**PORTAGE COUNTY
EMERGENCY OPERATIONS CENTER**

HAI Project No. 22048.001

To: All Bidders

This Addendum becomes a part of the Contract Documents and modifies the original Bidding Documents dated 4-25-2023, as noted below. The Bidder shall acknowledge receipt of this Addendum on the Form of Proposal. Failure to do so may subject the Bidder to disqualification.

1 FIRST FLOOR PLUMBING PLAN
P2-1 3/16" = 1'-0"

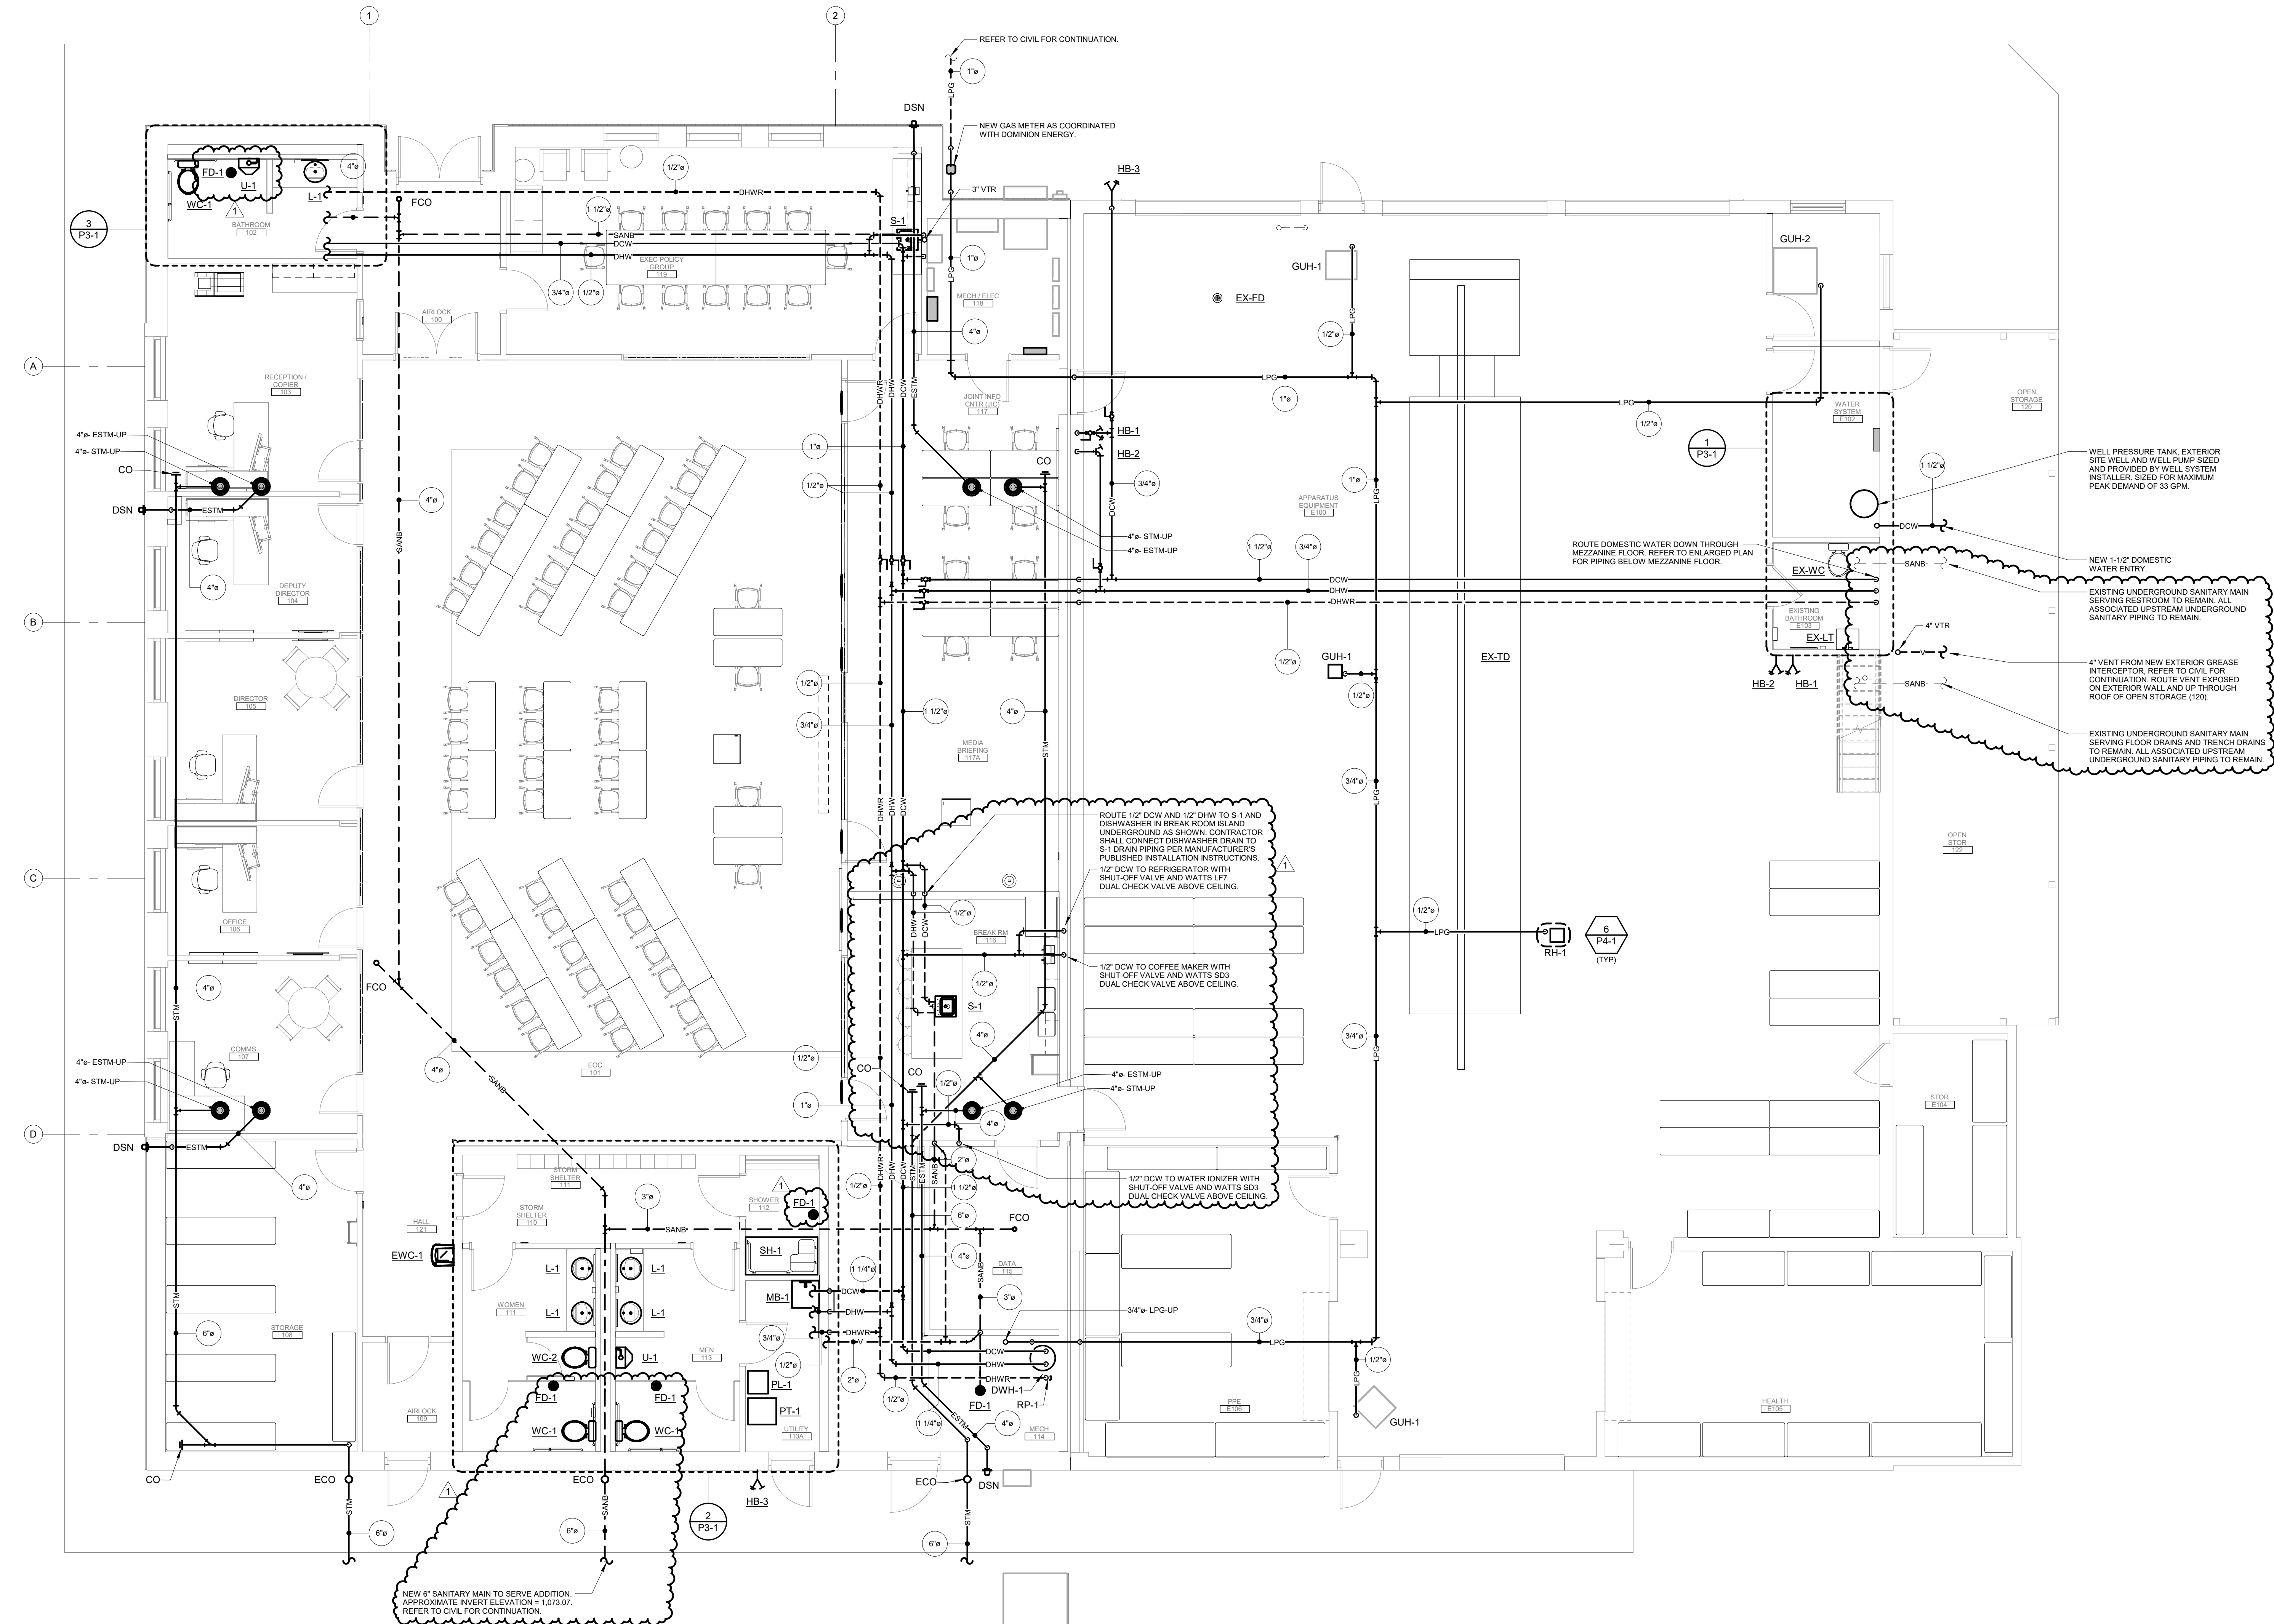
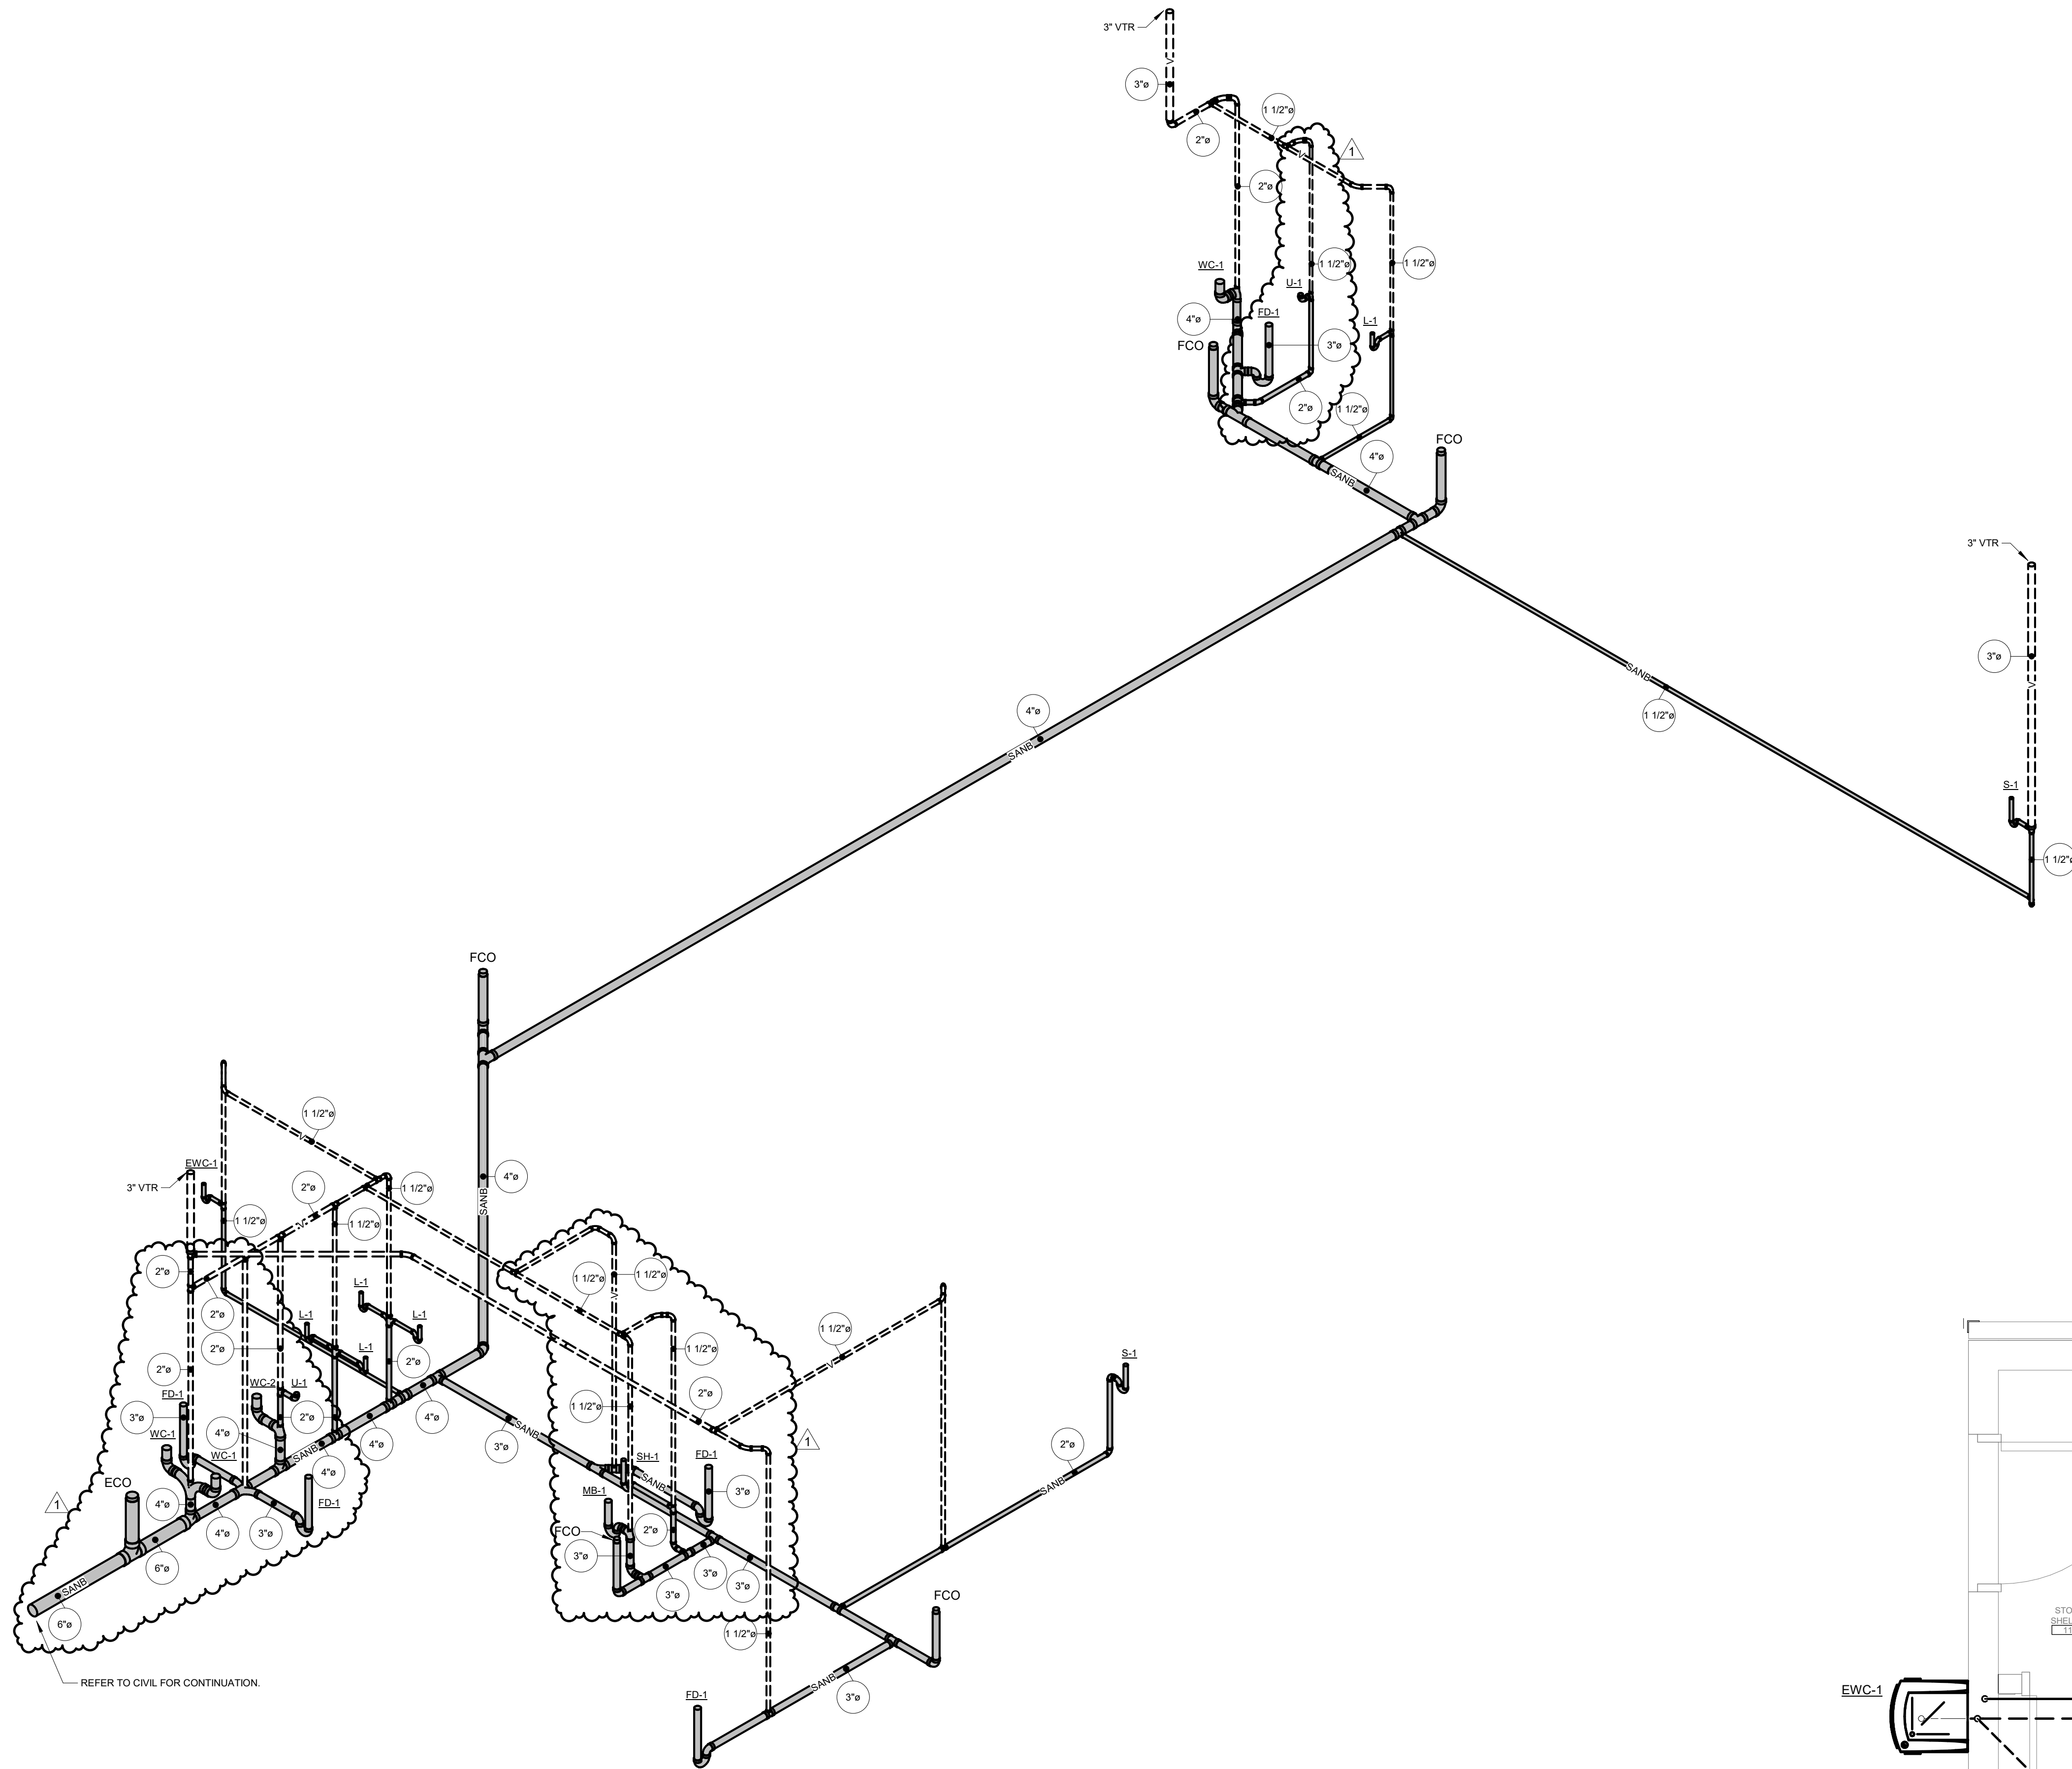
- a. P1-1 PLUMBING DEMOLITION PLAN
 1. REVISED TO CLARIFY EXISTING CONDITIONS.
- b. P2-1 PLUMBING PLAN
 1. REVISED TO INCLUDE FLOOR DRAINS IN BATHROOM (102), WOMEN (111), SHOWER (112), AND MEN (113).

2. REVISED TO INCLUDE ADDITIONAL EQUIPMENT WATER LINES IN BREAK ROOM (116).
 3. REVISED SANITARY MAIN INTO ADDITION TO 6" DIAMETER AND INCLUDED INVERT ELEVATION.

4. REVISED TO INCLUDE VENT LINE FROM EXTERIOR GREASE INTERCEPTOR.
- c. P3-1 ENLARGED PLUMBING PLANS AND SANITARY ISO
 1. REVISED TO INCLUDE FLOOR DRAINS IN BATHROOM (102), WOMEN (111), SHOWER (112), AND MEN (113).
